From: Rich Gold <[REDACTED]>
Sent: Monday, January 26, 2026 5:49 PM
To: tpbpd/PLAND <tpbpd@pland.gov.hk>
Cc: Selena Yin Ni SIN/PLAND <[REDACTED]>
Subject: Planning Application No. A/YL-KTS/1090 - Submission of Further Information

Submission of Further Information (FI)

Proposed Temporary Private Vehicle Park (Private Cars Only) for a Period of 3 Years in “Village Type Development” Zone, Lot 343 (Part) in D.D. 113, Kam Tin, Yuen Long, New Territories (Application No. A/YL-KTS/1090)

Further Information for Planning Application No. A/YL-KTS/1090
Response-to-Comments

Plan 5.1a
(P 25040)

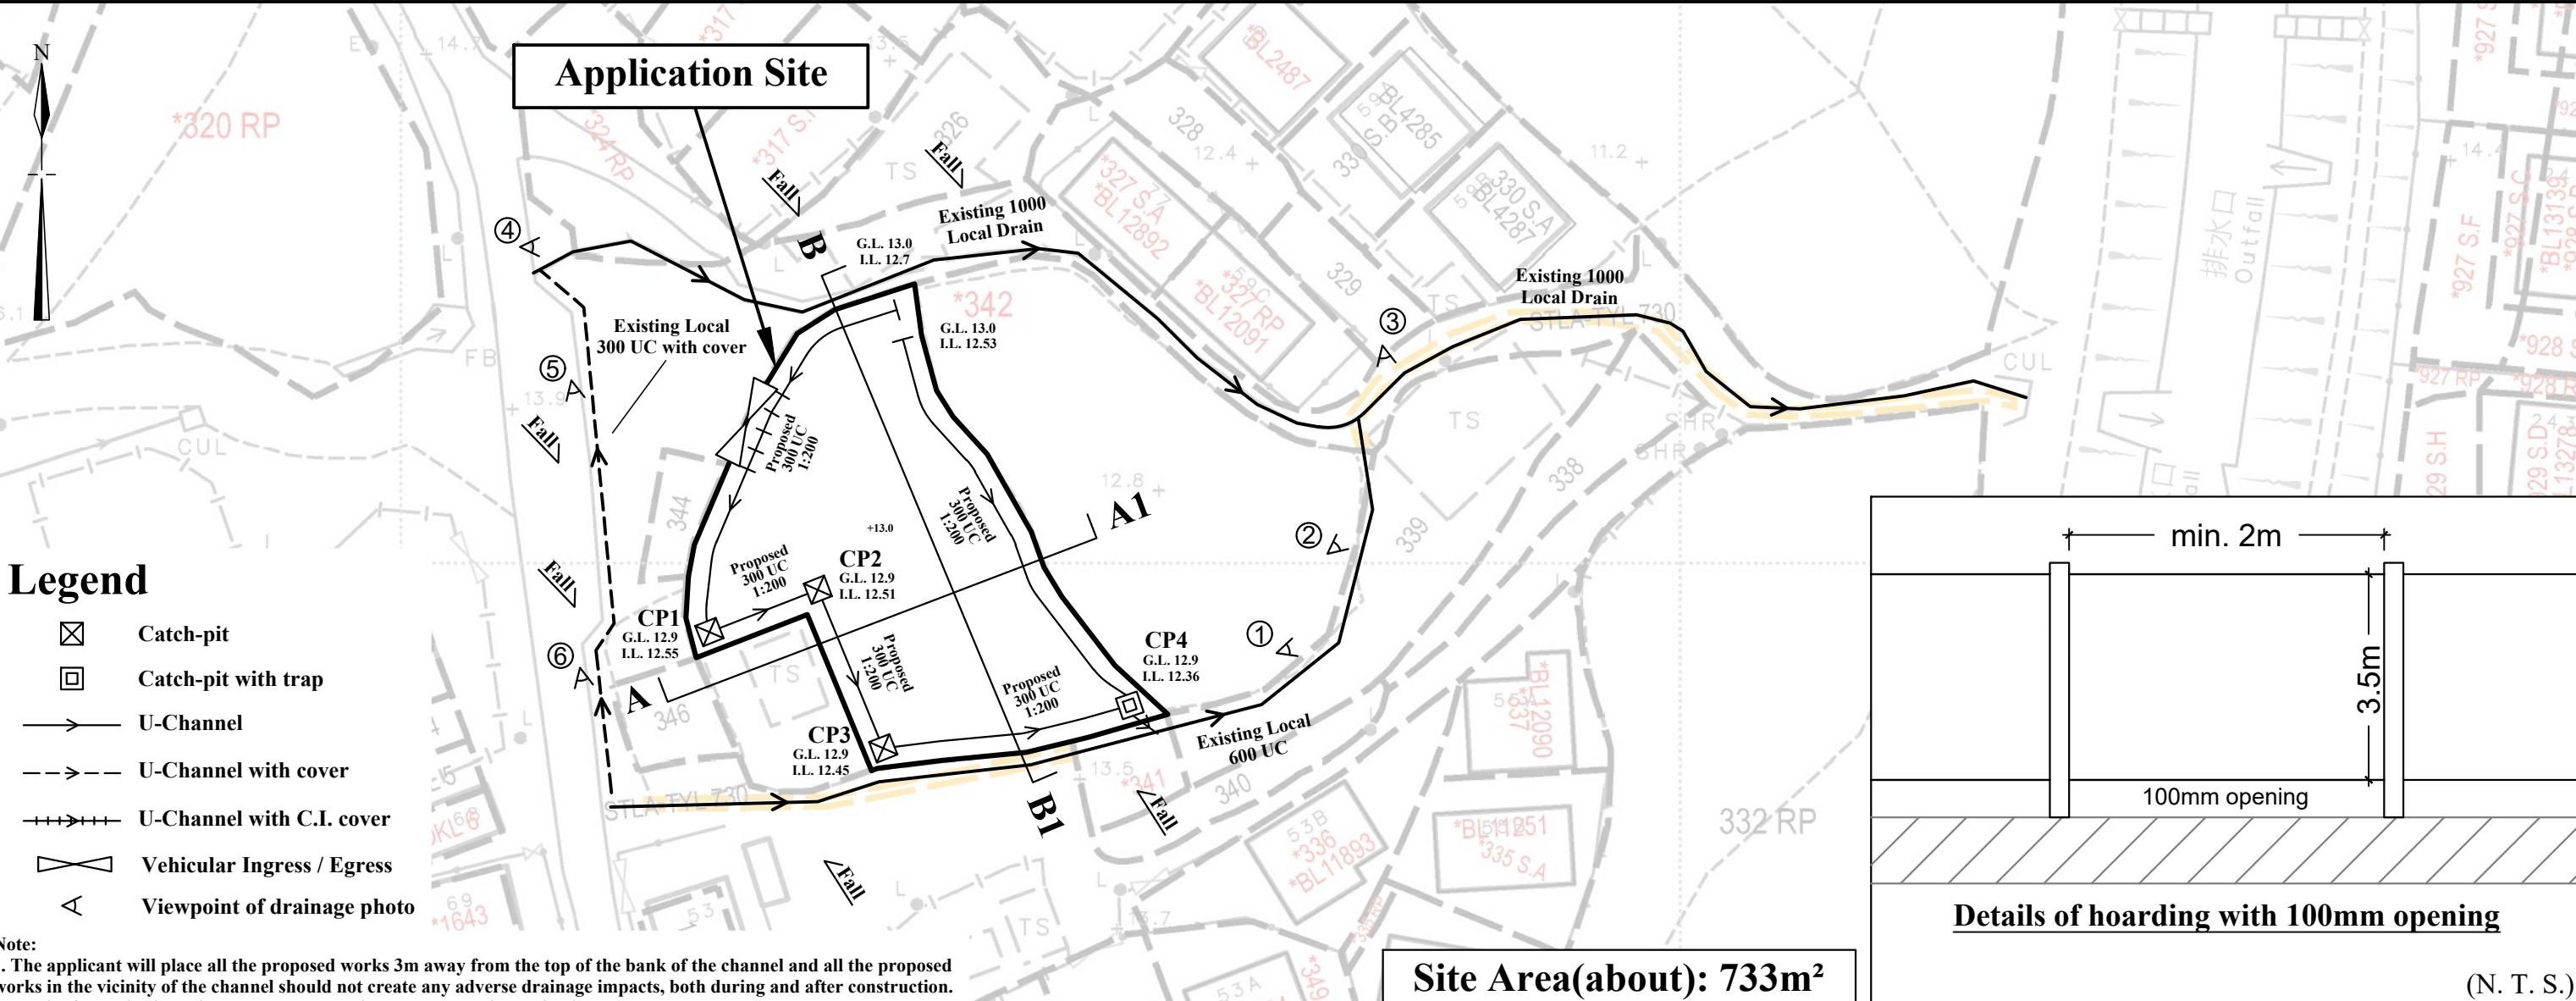
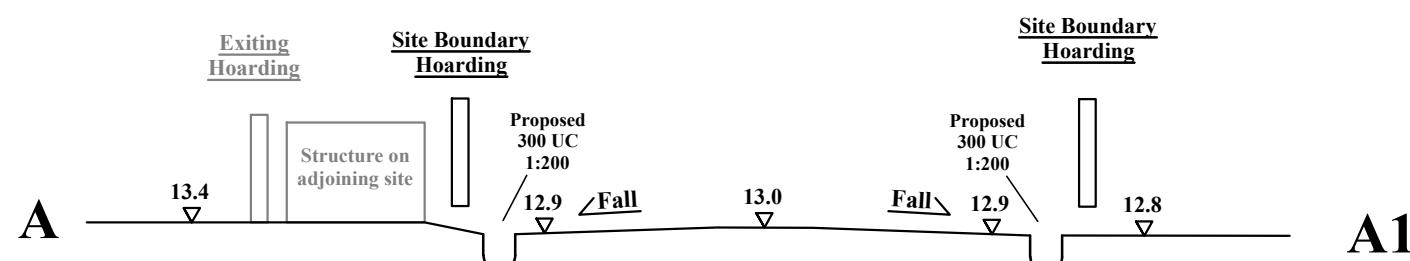
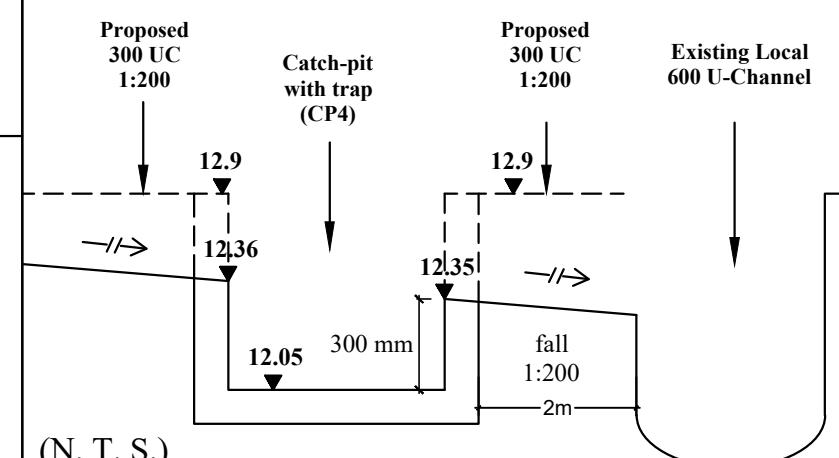
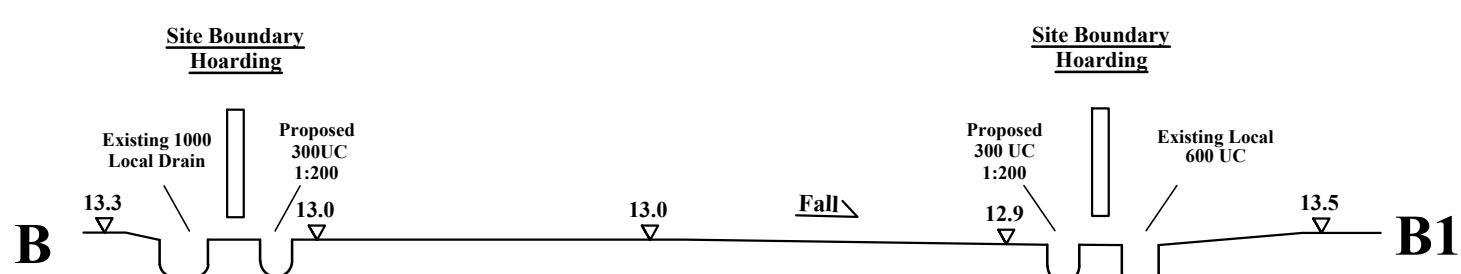
I.	Comments	Responses
1.	Referring to item 2 of the R-to-C provided, it is noted that all the proposed works will be placed 3m away from the top of the bank of the channel. Please clearly state the above on the drainage plan (Plan 5.1a) for record.	Noted. Please refer to Plan 5.1a.

3.	The details of the proposed 100mm gap at the toe of the hoarding should be shown on the drainage plan (Plan 5.1a instead of Plan 5.2a) for clarity.	Noted. Please refer to Plan 5.1a.

4.	Please advise if any site formation/levelling works to be carried out under this application. Cross sections showing the existing and proposed ground levels of the captioned site with respect to the adjacent areas should be given.	No site formation/levelling works to be carried out under this application. Please refer to Plan 5.1a.

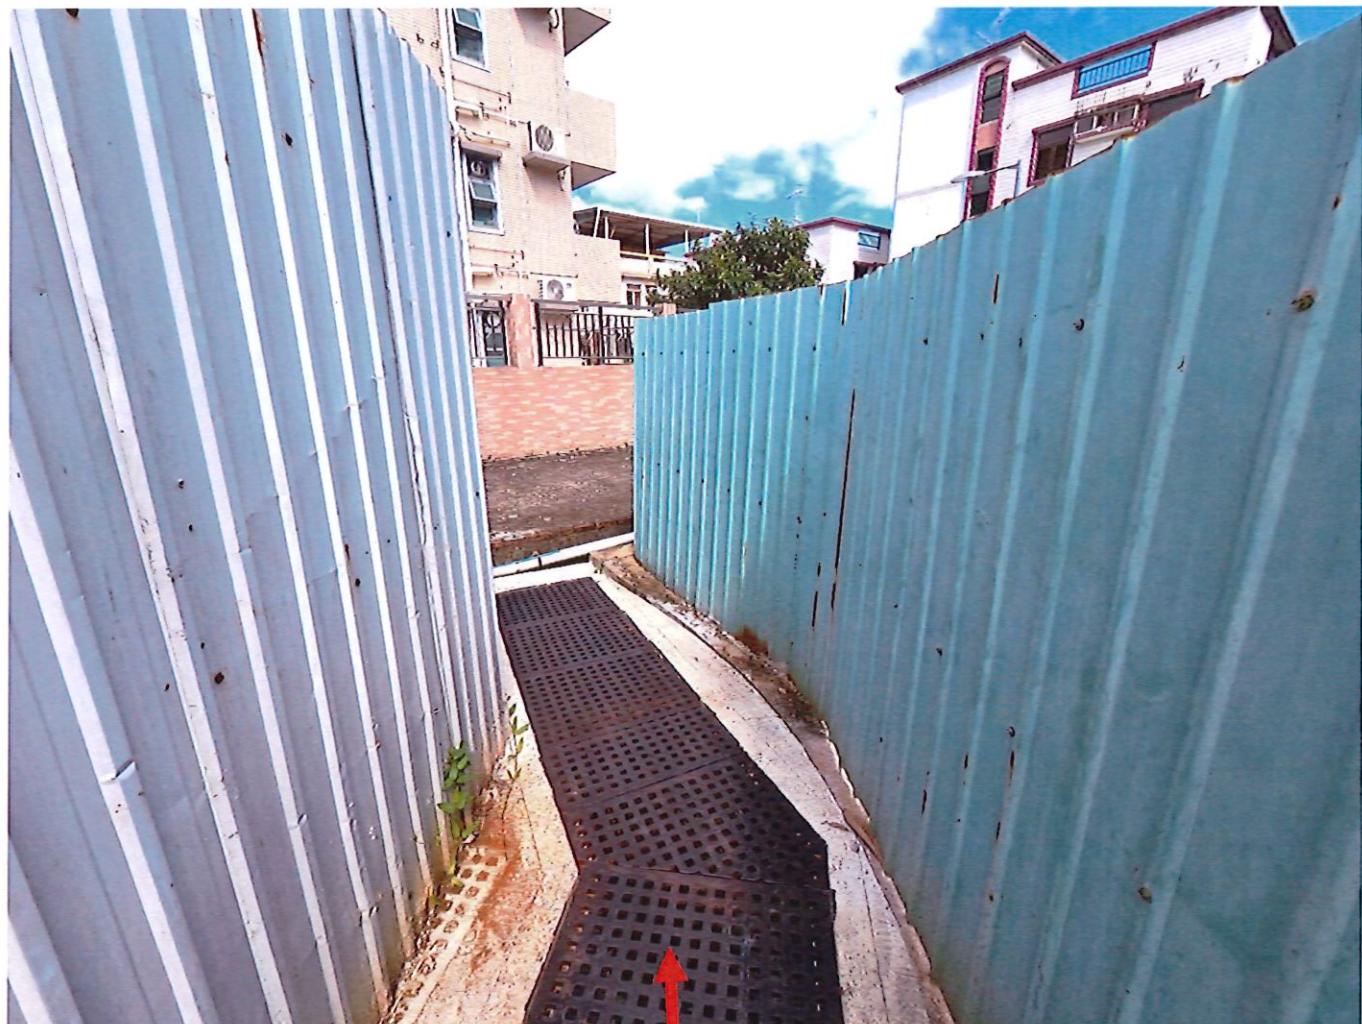
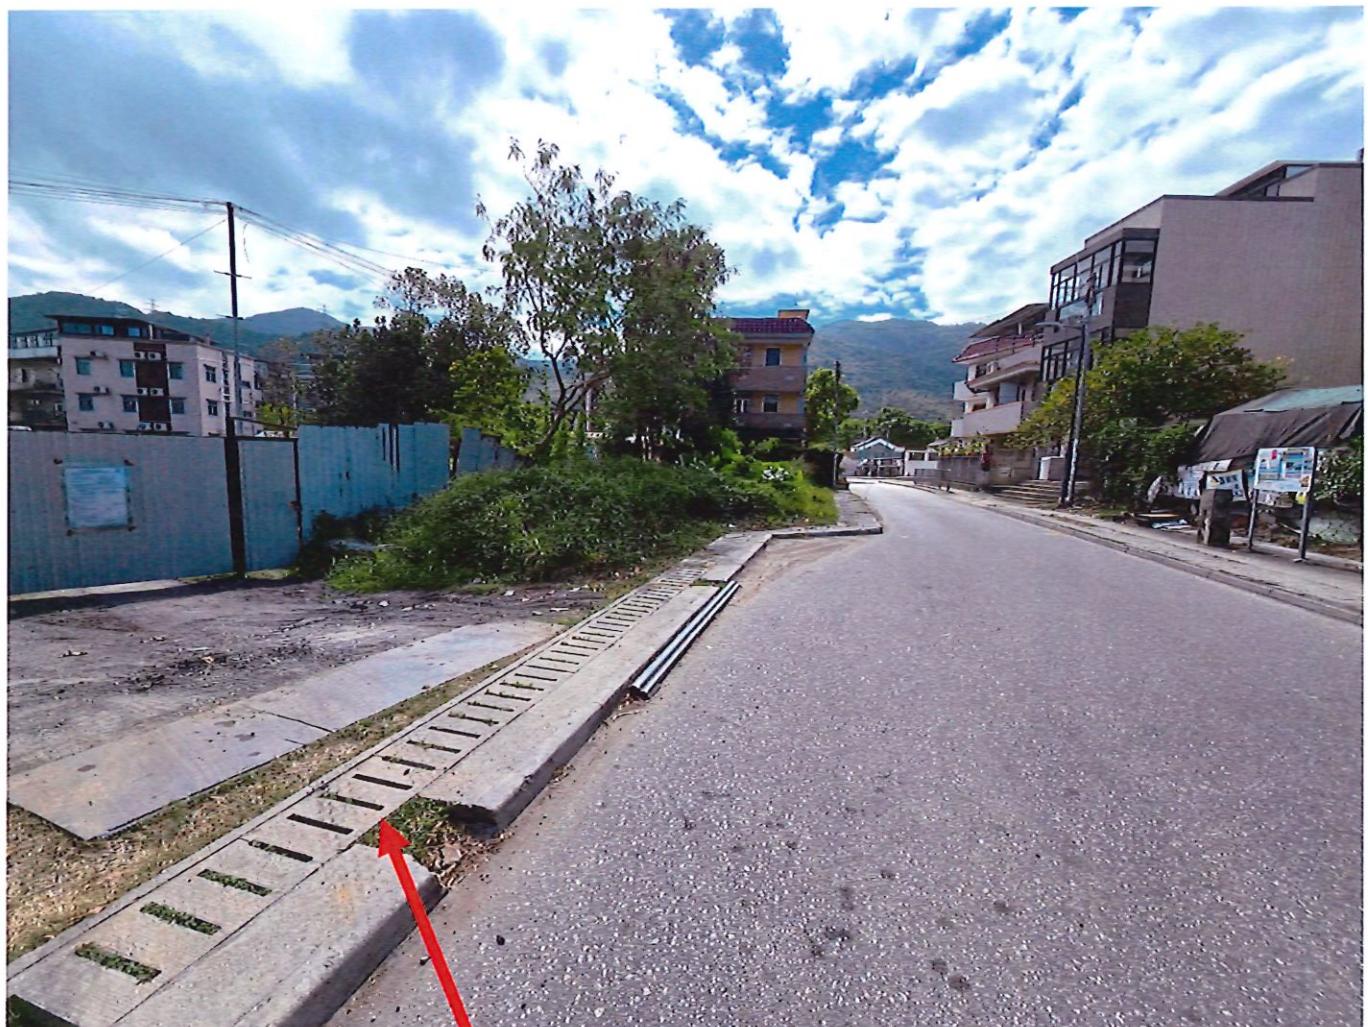
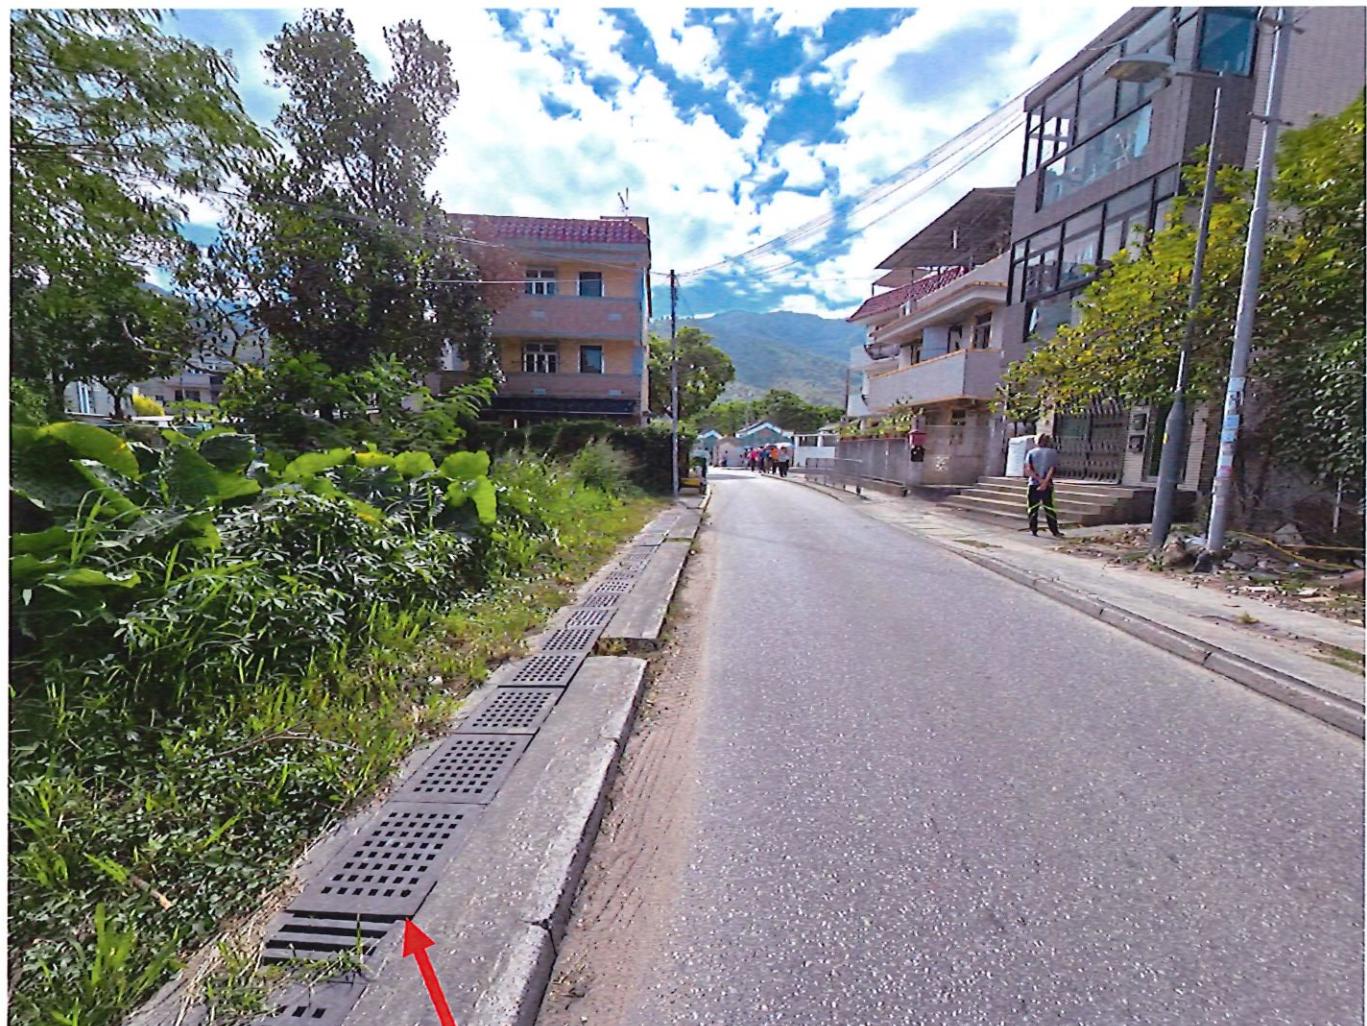
2.	Please provide site photos to demonstrate its presence and internal condition of the existing 300mm u-channel located at the western side of the application site for review.	Please refer to Viewpoint Photographs.
